From: Phil Goff and Chad Gibson, co-chairs
East Arlington Livable Streets (EALS) Coalition

Re: Comments in preparation of the 75% submittal of the Mass Ave Corridor project

Date: December 8, 2011

Raised crosswalks like this one on Mass Ave in Cambridge prioritize pedestrian and ADA access and slow turning traffic onto side streets

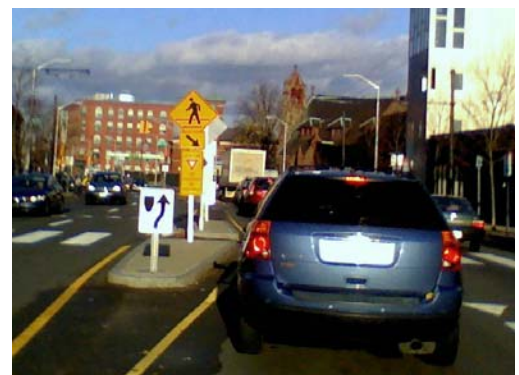
- Crosswalks:** The crosswalks that run parallel to Mass Ave cross numerous local service streets along the corridor, with the exception of Bates Road and Lake Street (both designated collector streets). All cross streets are exclusively residential and house many families with young children. Vehicles turning off of, or onto Mass Ave, frequently encroach on to the crosswalk and make the turn too quickly. We are happy to see that the project reduces the turning radii on some of the side streets perpendicular to Mass Ave. We also recommend the inclusion of raised crosswalks or speed tables into the plan, especially at the side streets that suffer the most significant problems with cut-thru traffic and speeding (i.e. those that offer direct connections between Mass Ave and Broadway). Raised crosswalks will slow turning traffic and encourage vehicles to come to a complete stop prior to the crosswalk. This is a critical safety feature that puts priority on pedestrians walking along Mass Ave, rather than vehicles turning onto side streets. In areas with the highest level of pedestrian traffic—the blocks between Grafton/Orvis and Milton Street—the raised crosswalks will help to define the Capitol Square business district and encourage drivers to become more aware of those on foot in this area.
